1. Please use the following table headers and provide a table for each activity proposed, acreage of impact and habitat being impacted by that activity. If docks impact more than one habitat, please place them on a separate line so that each habitat has its quantified impacts per activity being proposed.

2. The proposal includes the installation of 12 mooring buoys with the inclusion of 75 mooring buoys as compensatory mitigation. The Corps has not determined that the 75 mooring buoys is appropriate for compensatory mitigation at this time as we have just begun compiling the functional assessment of the project impacts. Therefore, this is to inform you that if it is deemed inappropriate or unnecessary for the 75 mooring buoys to provide compensatory mitigation if the wish is to still have them a modification to any permit issued would be required in order to install the 75 buoys.

Figure 2a. Action area-Indirect Impacts.

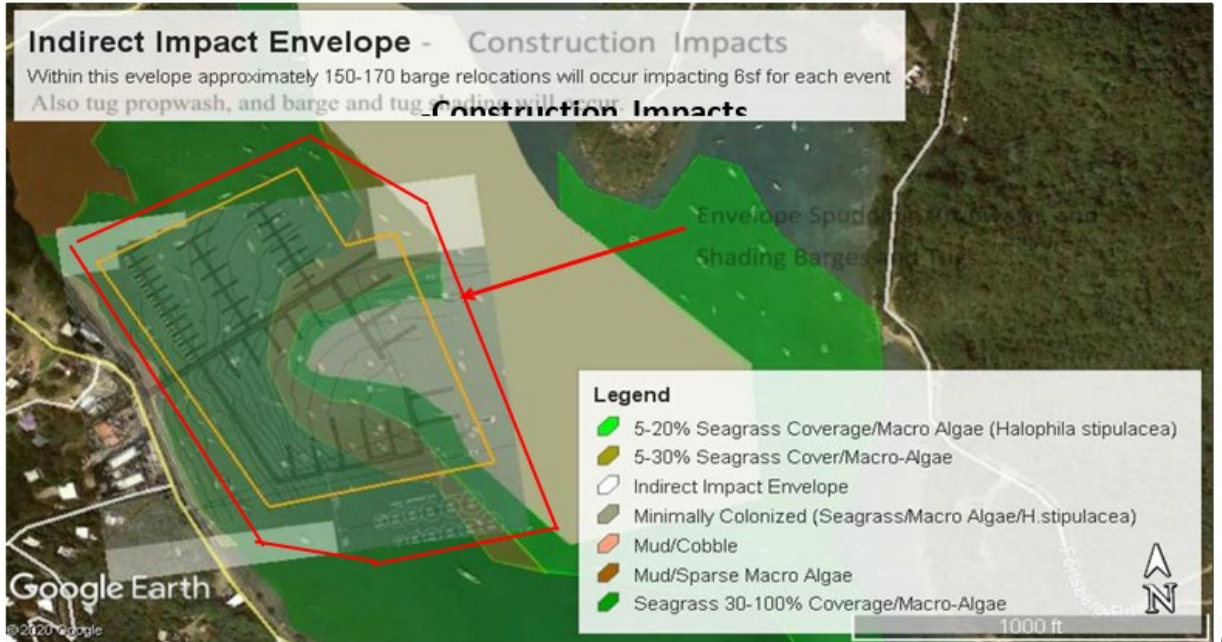
10. Explain the difference between the two color envelopes and how they were determined

Figure 2b. Action area-Potential turbidity impacts.

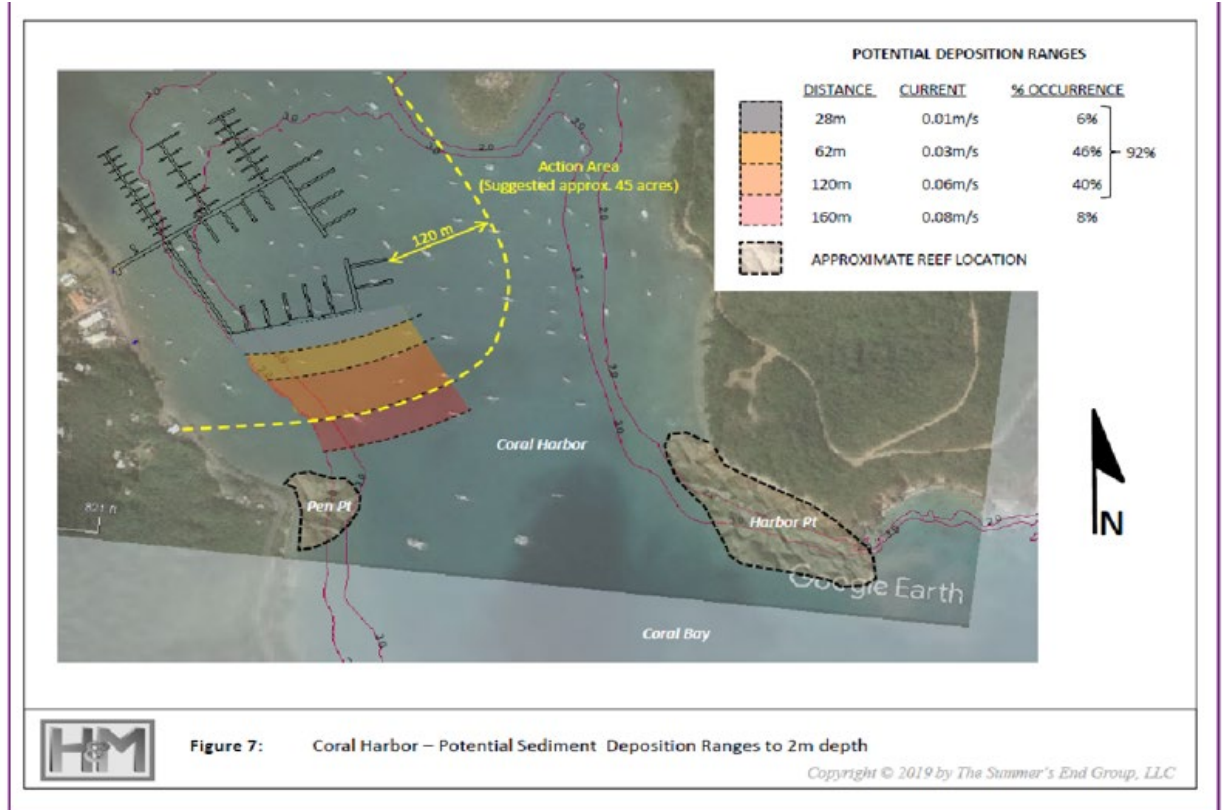
11. Explain how these deposition ranges according to distance were produced and under what assumptions – Or reference a document as to where this information is discussed:
